Federal Way Community Center

AS-BUILTS

Sheet Title:
FOUNDATION DETAILS AND SCHEDULE

S402

6 S402 TYPICAL PLASTER SECTION
SCALE: 1" = 1'-0"

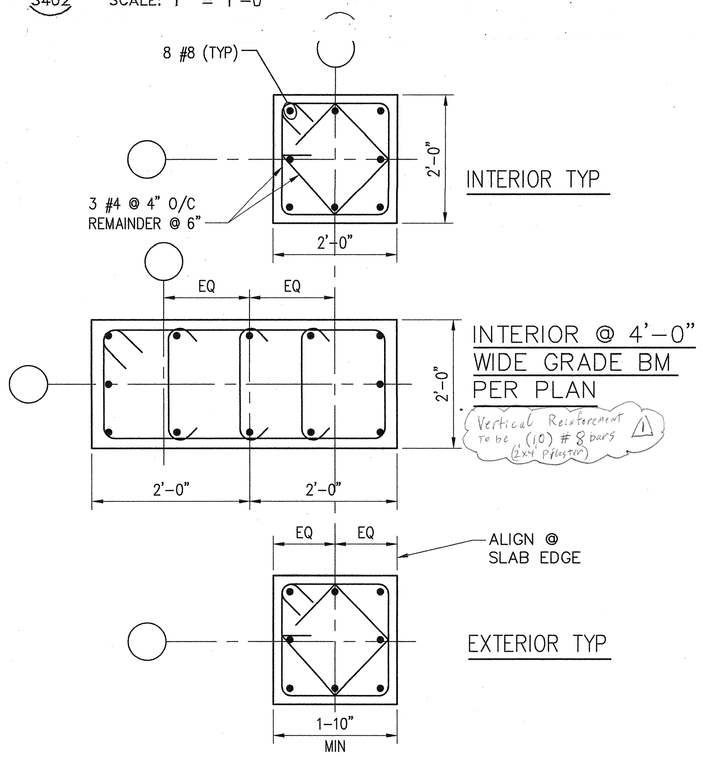
RFI # 128, 1/9/6, TCC
Q: On S102 at the elevator pit there is a F2 spread footing, a pilaster, and a C2 column that centers on grid lines N.E, and N.4. Per detail 6/S402 the pilaster is 2' X 2'. Go to detail A15/A500 and detail H32/A500 dimensions look to be 2 1/2" from grid line N.4 to inside face of wall, and H32 has the grid line inside the shaft. RFI # 80 Noted that detail A15/A500 is the intended location of the wall along grid line N.4.
Please confirm location of elevator shaft wall to grid lines N.4 and N.E.
Also if dimensions to center line of column is correct from grid line N.4 and N.E the pilaster will be protruding into the elevator shaft pit, is this acceptable?
A: See attached sketch sheets 1 & 2. Pilaster size has been reduced to 16X20. The projected dimensions noted have been coordinated with Pete of the elevator supplier. Please note that elevator pit has been moved west by 1 inch.

Please provide reinf as shown for the 2' X 2' pilaster.
